# **AMD-K6<sup>®</sup>**

## **Processor Revision Guide**

### **Model 7**

Publication # <b>21846</b> Rev: <b>H</b> Amendment/ <b>0</b> Issue Date: <b>June 1999</b>
--

**Figure 1. AMD-K6<sup>®</sup> Processor Assertion of HLDA Due to Simultaneous  $\overline{\text{BOFF}}$ /HOLD Assertion**

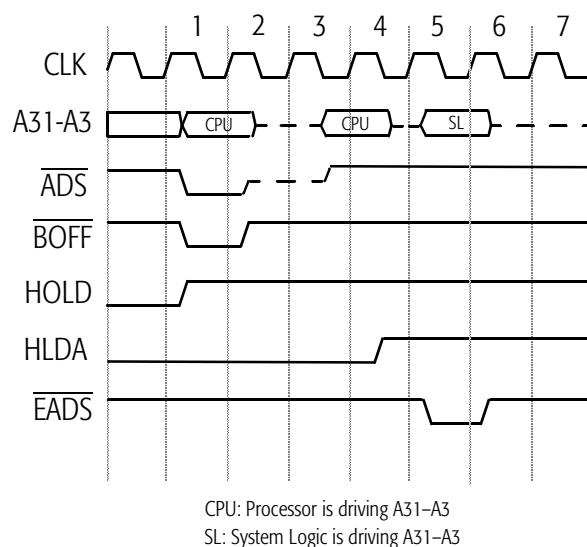
**Non-conformance.** If  $\overline{\text{BOFF}}$  and HOLD are sampled asserted on the same clock edge that negates  $\overline{\text{ADS}}$ , the processor asserts HLDA two clock edges after HOLD is sampled asserted.

- If the system logic asserts  $\overline{\text{BOFF}}$  for a duration of one clock, anticipates the assertion of HLDA in clock 3 (see Figure 1)—which is the normal specified operation—and drives the address bus and  $\overline{\text{EADS}}$  for an inquire cycle in clock 3, then the processor will not sample  $\overline{\text{EADS}}$  asserted. In addition, address bus contention will occur in clock 3.

- If the system logic asserts  $\overline{\text{BOFF}}$  for a duration of two clocks, anticipates the assertion of HLDA in clock 3, and drives the address bus and  $\overline{\text{EADS}}$  for an inquire cycle in clock 3, then the processor will not sample  $\overline{\text{EADS}}$  asserted. (No address bus contention occurs in this case.)

- If the system logic asserts  $\overline{\text{BOFF}}$  for a duration of one clock, anticipates the assertion of HLDA in clock 3, and drives the address bus and  $\overline{\text{EADS}}$  for an inquire cycle in clock 4, then address bus contention may occur in clock 4. (The processor will sample  $\overline{\text{EADS}}$  asserted in this case.)

If the processor does not sample  $\overline{\text{EADS}}$  asserted during an inquire cycle, cache/memory incoherency will occur. Address bus contention can affect the reliability of the processor and the system logic.

**Suggested Workaround.** The system logic must sample the assertion of HLDA before asserting  $\overline{\text{EADS}}$  and driving the address bus for an inquire cycle—as shown in clock 5 of Figure 1.
